STAFF REPORT
TBG ARCHITECTS
DRIVE-THROUGH FINANCIAL INSTITUTION / BANK BUILDING
CONDITIONAL USE PERMIT CUP 4-22
JANUARY 18, 2023

City of Cottage Grove File(s): CUP 4-22 and SDR 4-22

**COTTAGE GROVE BRANCH
OREGON COMMUNITY CREDIT UNION**
SITE DESIGN REVIEW & CUP
150 GATEWAY BLVD
COTTAGE GROVE, OREGON 97424

SHEET **C1.0**

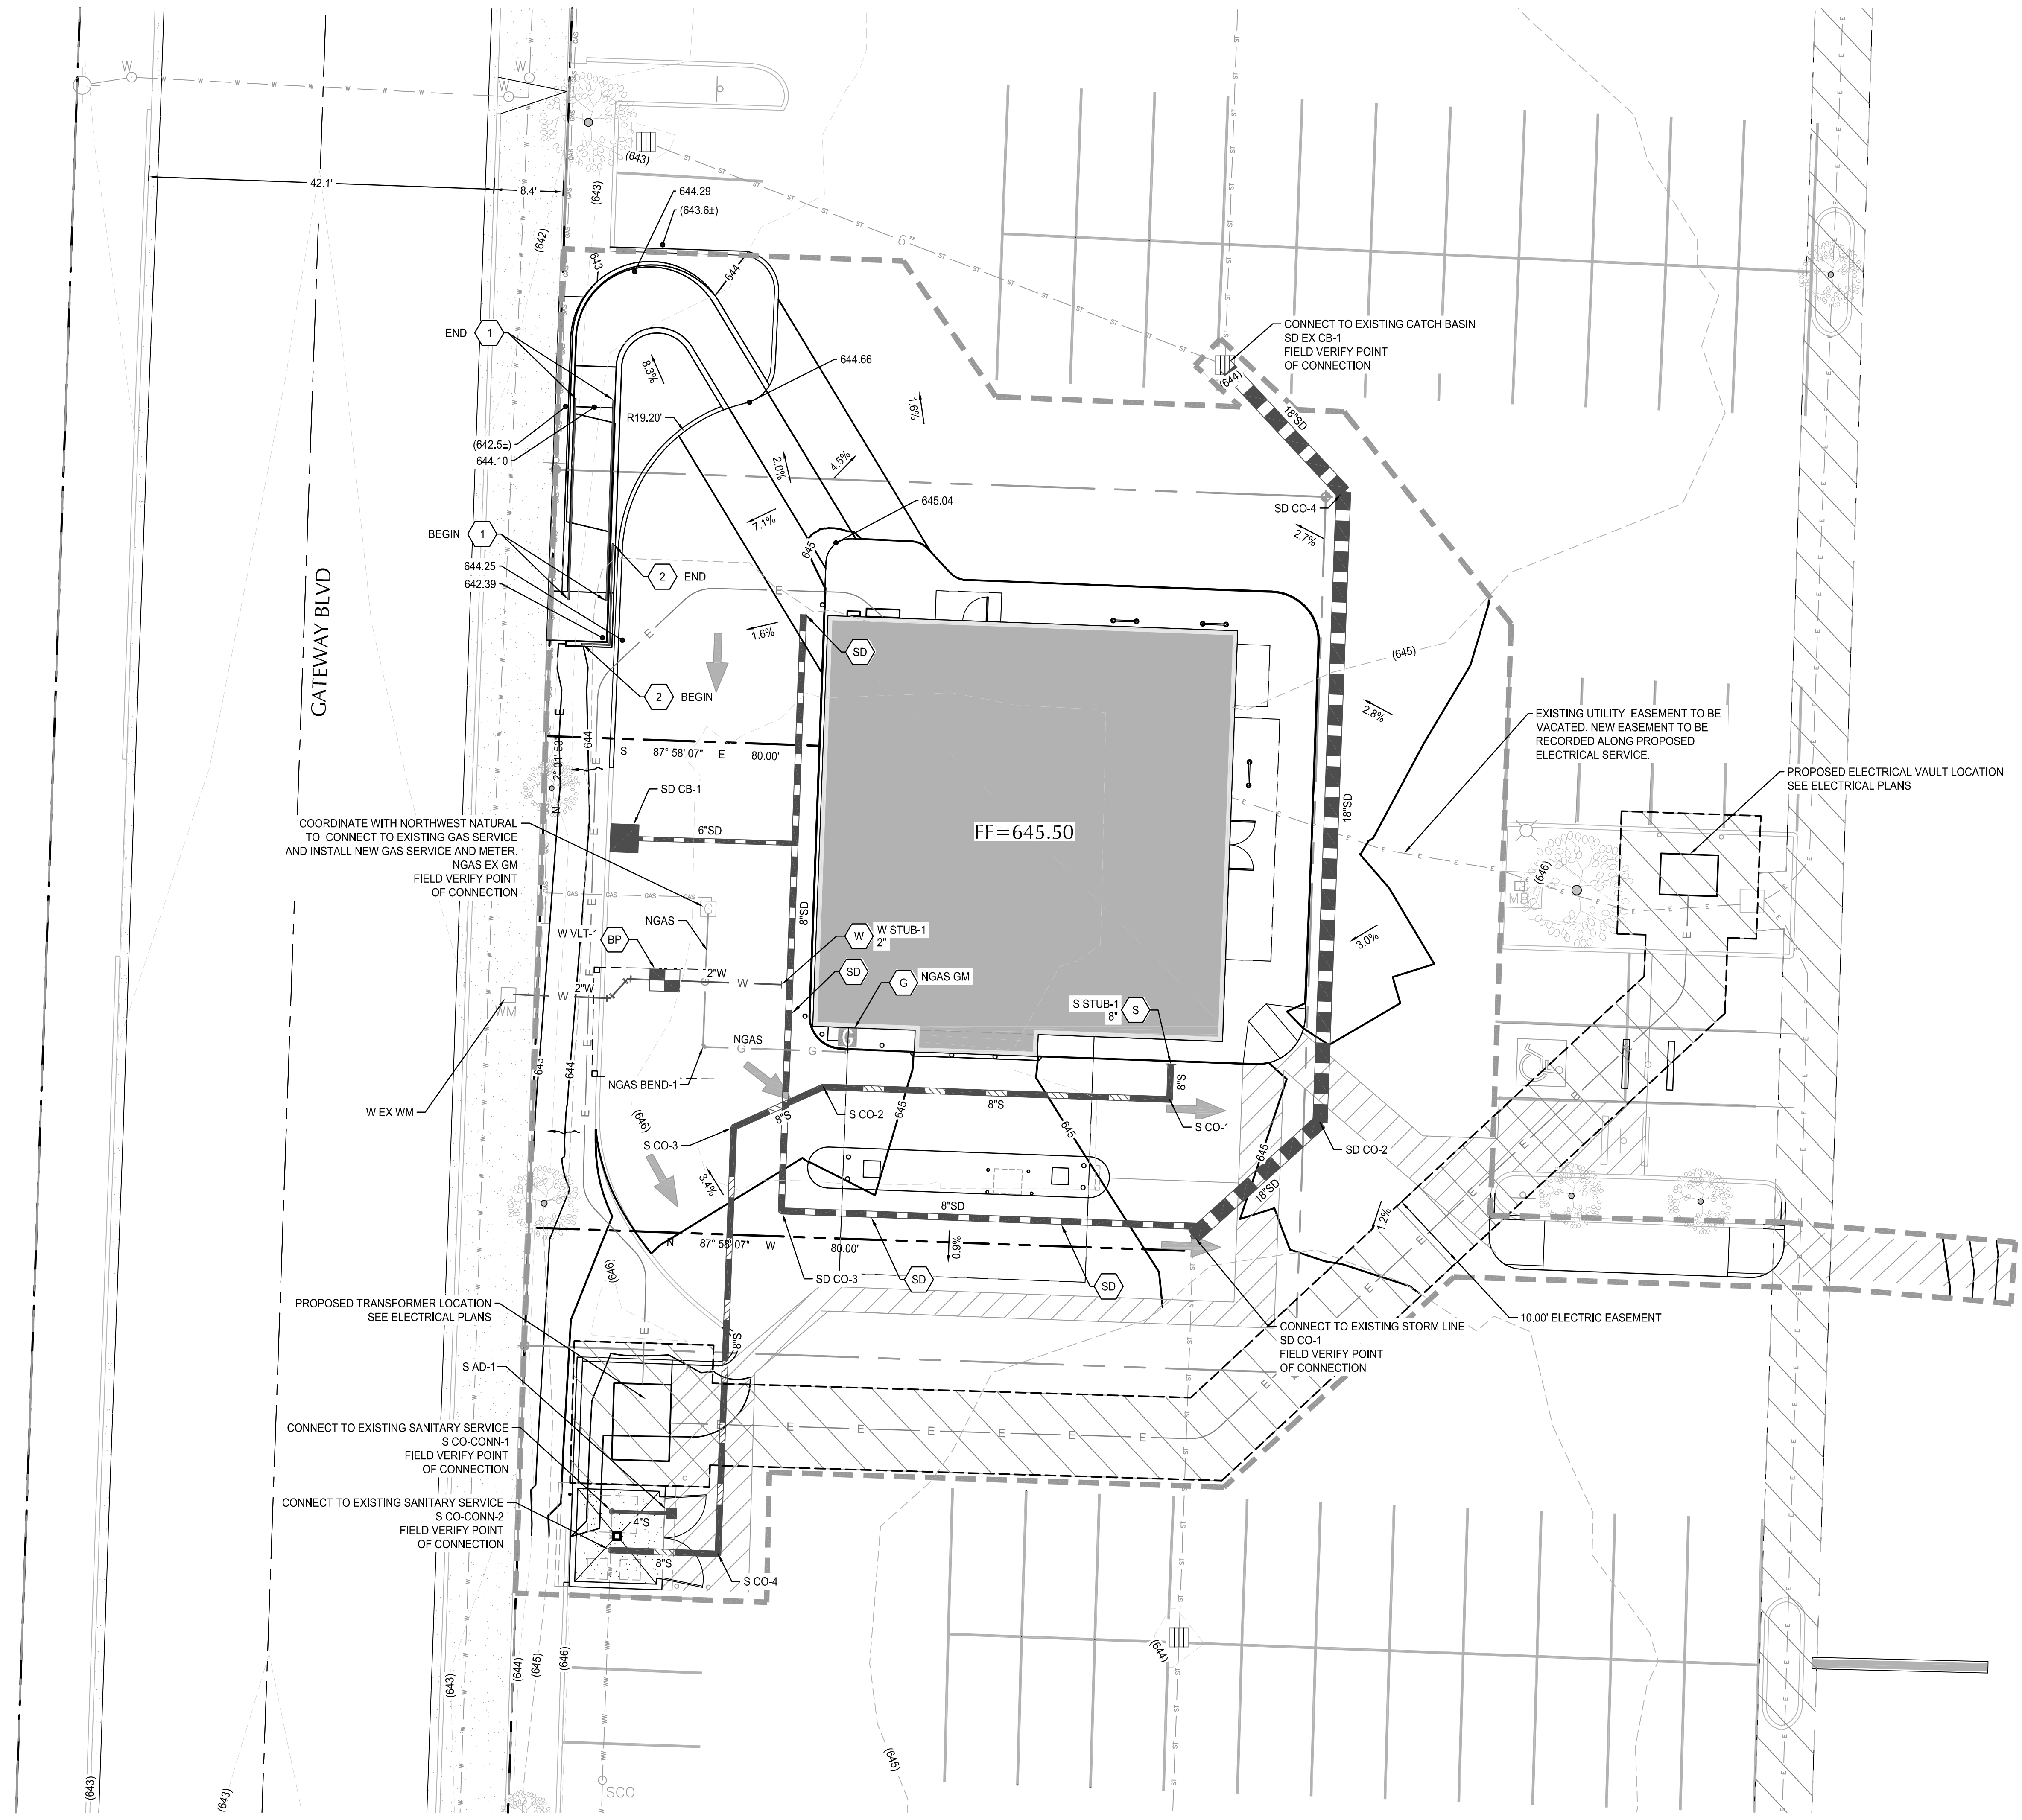
- Water service lines shall be copper.
- There is a public fire hydrant approximately 100-feet away, across the street on Gateway Blvd. Applicant should verify with the Fire Marshal if adequate hydrant access is provided.

- Show irrigation lines, number of sprinkler heads and irrigation zones as well as any irrigation meter on the building permit plans.
- Show water fixtures for each unit on the building plans so staff can check meter size for each unit as outlined in the plumbing code.

- Please include any hose bibbs on the building permit plans. Please indicate which water service they are to be attached too.

- Plans show a new 8-inch sanitary sewer lateral from the building to be connected to the existing sewer service. It is believed that sewer service is currently a six-inch line. Applicant should field verify. This is a heads-up item to be addressed under the plumbing permit.
